ET 02-0004

Docket 50-482: Inservice Inspection Program Alternative for

Limited Examination on Carbon Steel Piping Welds, Relief Request

12R-27

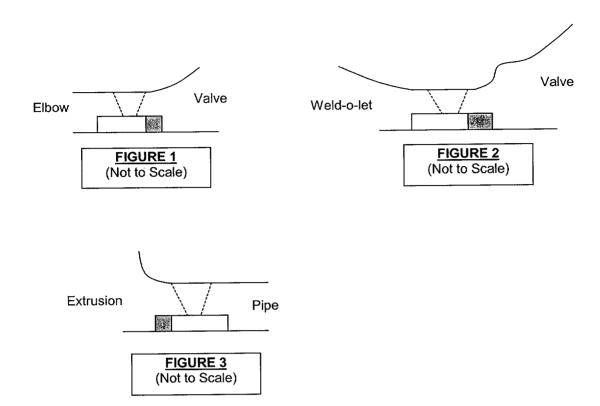
Weld AE-04-F033 connects a 4-inch elbow to a 4-inch valve. Due to the configuration of the joint, parallel coverage on 25 per cent of the Weld Required Volume (WRV) on the valve side of the weld cannot be obtained. The shaded area in Figure 1 illustrates the volume that cannot be examined.

Weld AE-04-F043 connects a 3-inch weld-o-let to a 3-inch valve. Due to the configuration of the joint, parallel coverage on 34 per cent of the WRV on the valve side of the weld cannot be obtained. The shaded area in Figure 2 illustrates the volume that cannot be examined.

Weld AB-01-F035 connects a 4-inch extruded outlet from the 28-inch main steam header to a 4-inch pipe. Due to the configuration of the extrusion, parallel coverage on 26 per cent of the WRV on the extrusion side of the weld cannot be obtained. The shaded area in Figure 3 illustrates the volume that cannot be examined.

- 1) The subject welds have been examined to the fullest extent practical. WCNOC proposes that the completed examinations be considered an acceptable alternative to the augmented inspection requirements.
- 2) Periodic System Leakage Tests per Category C-H, Table IWC-2500-1, provide additional verification of component integrity.
